RECEIVED
NOV - 8 2011
PERMIT CENTER
ALAMEDA, CA 94501

PROPOSED FOUND. REPLACEMENT
HISTORICAL RESTORATION
AT 500-CENTRAL AVENUE
ALAMEDA CA
FOR MR. DOMINIC NGUYEN

FIRST & SECOND FLOOR PLAN

SHEET NUMBER: A.1

FIRST FLOOR

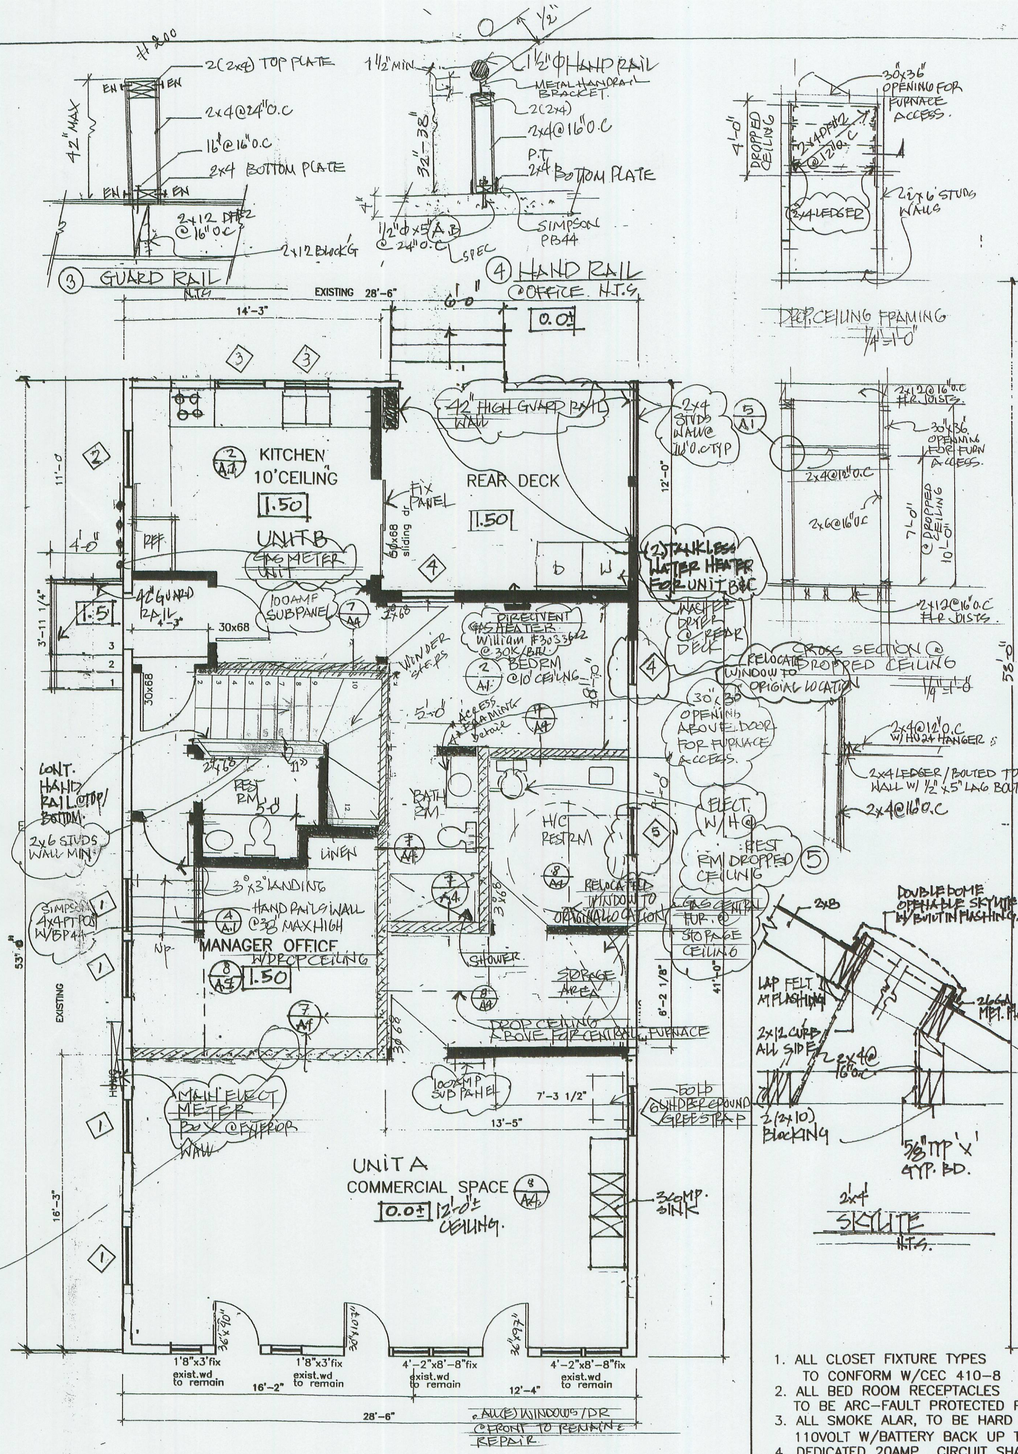
8.15.2011
1. REVISE DRYER LOCATION UNIT B
2. REVISE CENT. FURNACE FOR UNIT A
3. REVISE ELECT/GAS METER LOCATION
4. REVISE GUARD RAIL WALLS @ REAR DECK
5. REVISE WATER HEATER LOCATION FOR A/B
6. REVISE SUB PANEL LOCATION /UNIT A/B

2ND FLOOR

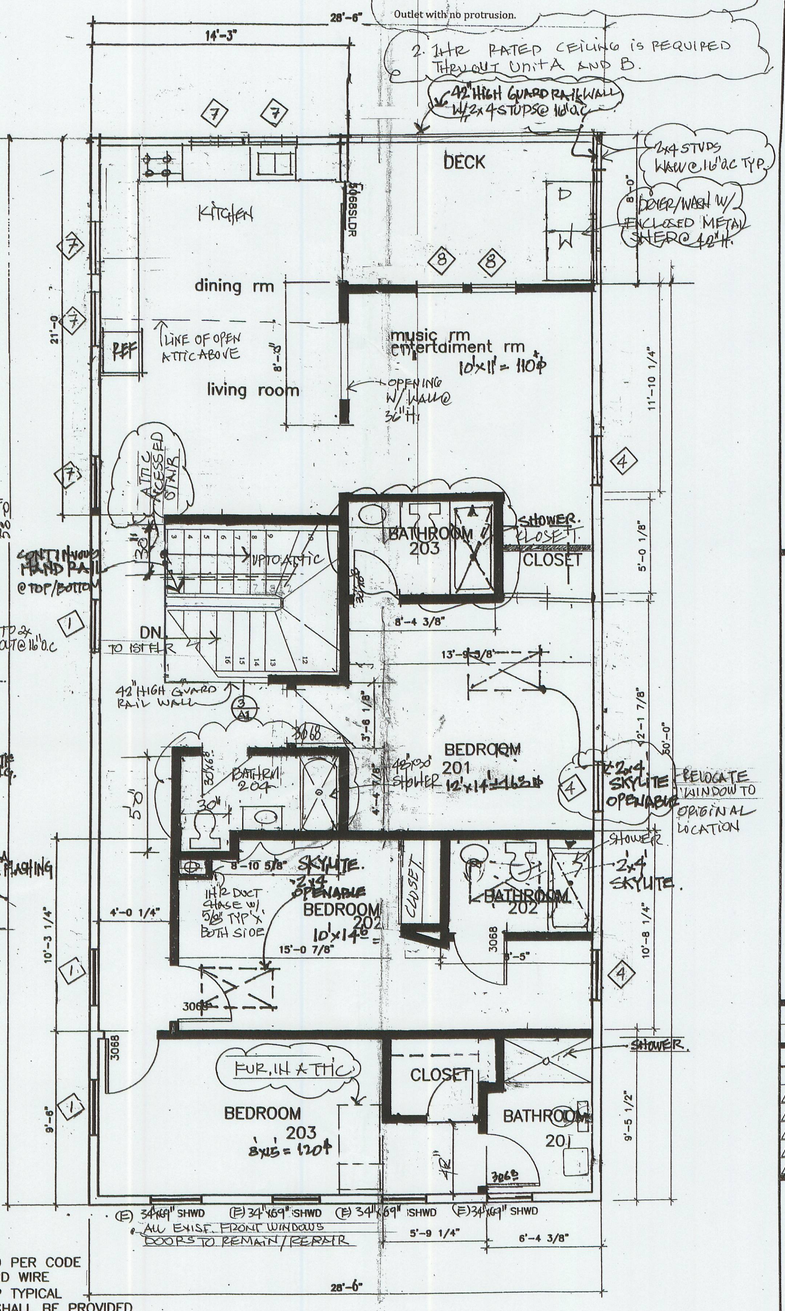
8.15.2011
1. REVISE BATHRM 203
2. REVISE BATHRM 204
3. REVISE WASH/DRYER LOCATION
4. REVISE ATTIC 'ACESSED STAIR
5. REVISE CENTRAL FURNACE LOCATION
6. REVISE GUARD RAIL WALL @ RW DECK

ELECTRICAL FIRST FLOOR ILAN

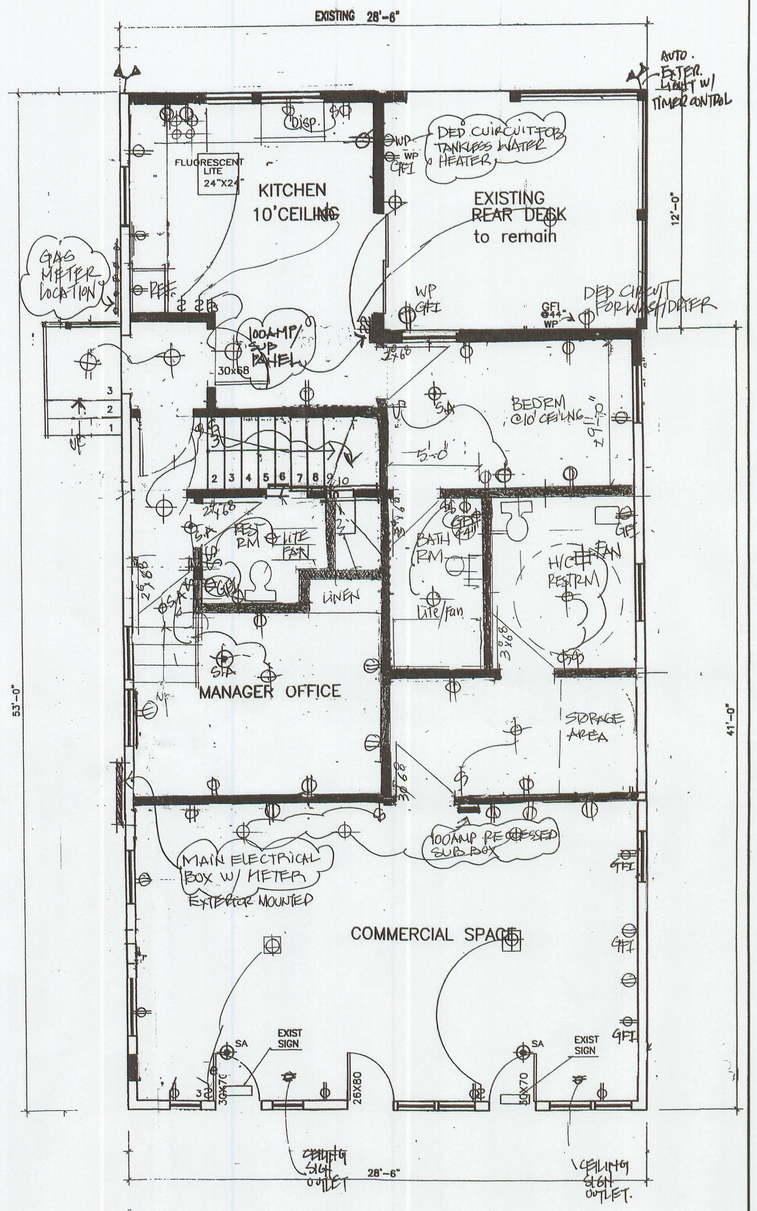
1. REVISE ELECT. SUB BOX FOR UNIT A/B
2. REVISE MAIN ELECTRICAL BOX W/METER LOCATION
3. REVISE GAS METER LOCATION.
